**Reactor Oversight Process Frequently Asked Questions – November 20, 2013**

**FAQ Log Entering ROP Public Meeting November 20, 2013**

Attachment 1 - Reactor Power vs Time

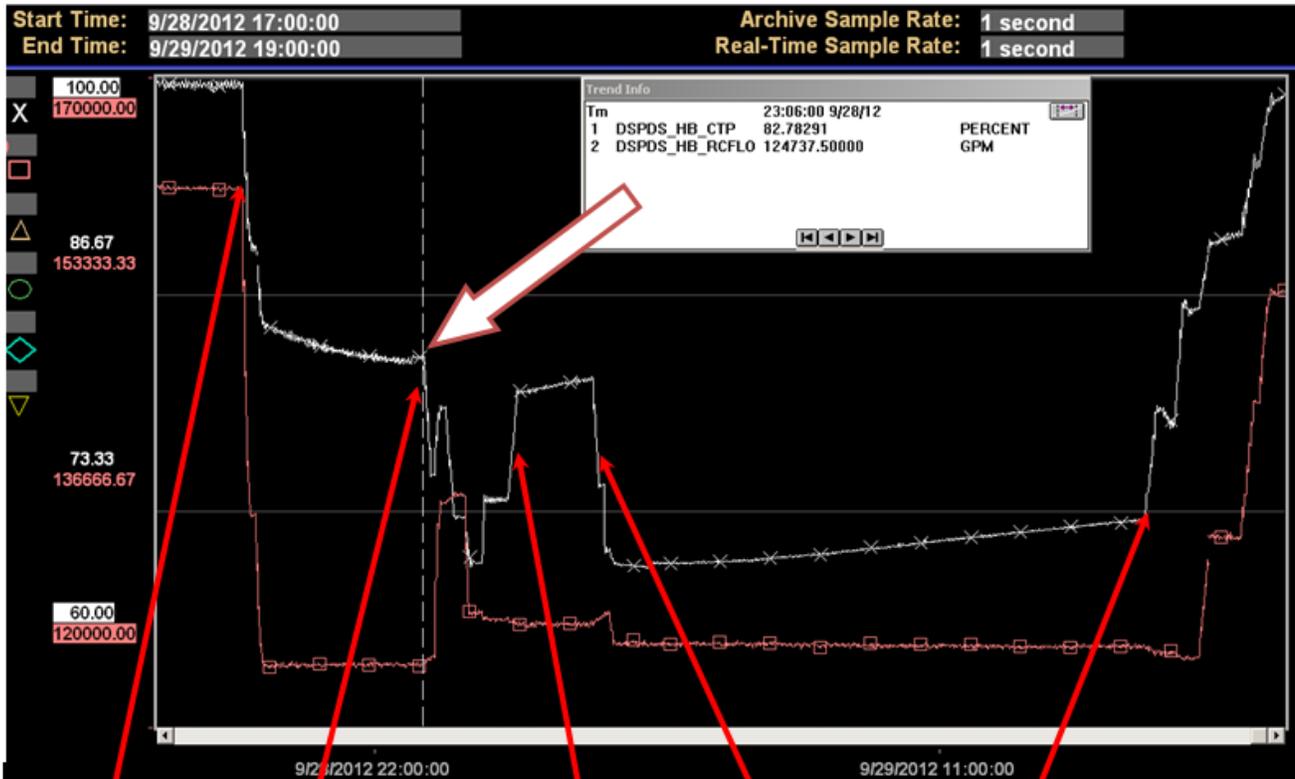
The NRC resident inspection staff does not agree that the guidance provided in NEI 99-02 excludes the duration of a downpower from consideration when determining whether a downpower should count against this performance indicator. NEI 99-02 revision 6, page 14, lines 10-14 state:

The NRC resident inspection staff determined that this downpower should count for the following reasons:

- The initial downpower was due to address an off-normal condition (the leak on the circulating water piping) and occurred approximately 4 hours before scheduled power reduction for control rod conditioning.
- The licensee reduced power by a total of 30% to perform the repair and resolve the equipment problem.
- The equipment problem was not repaired during the planned power reduction.

An emergent downpower to 85% was initiated to address circulating water piping leak. The emergent downpower was scheduled to coincide with a planned downpower to 73% for End of Cycle Rod Maneuvers (rod pattern adjustments). Repairs commenced during the emergent downpower and continued into the planned power reduction significantly reducing the leakage (to approximately 1 gpm). The emergent downpower was < 20 and therefore outside the scope of the performance indicator.

During power ascension from the planned power reduction for rod pattern adjustments, a decision was made to halt the power ascension at 80%, reduce power to 70%, and perform additional repairs to further reduce or eliminate leakage from the circulating water piping repair prior to returning to 100% power.

- The power reduction to 70% was outside of the preplanned evolution which ended at 0033 on 9/29/12
- The power reduction to 70% was < 20% below the previous power level of 80%
- A power reduction to 70% was not required for the additional repairs
- Power level had not been restored to 100% following completion of the planned power reduction.

The emergent and preplanned power reduction should be evaluated as two power reductions as opposed to one continuous power reduction to 73%. The power reduction from 80 to 70 should not be counted as an unplanned power reduction since it was not >20% from the preplanned or the previous power level.
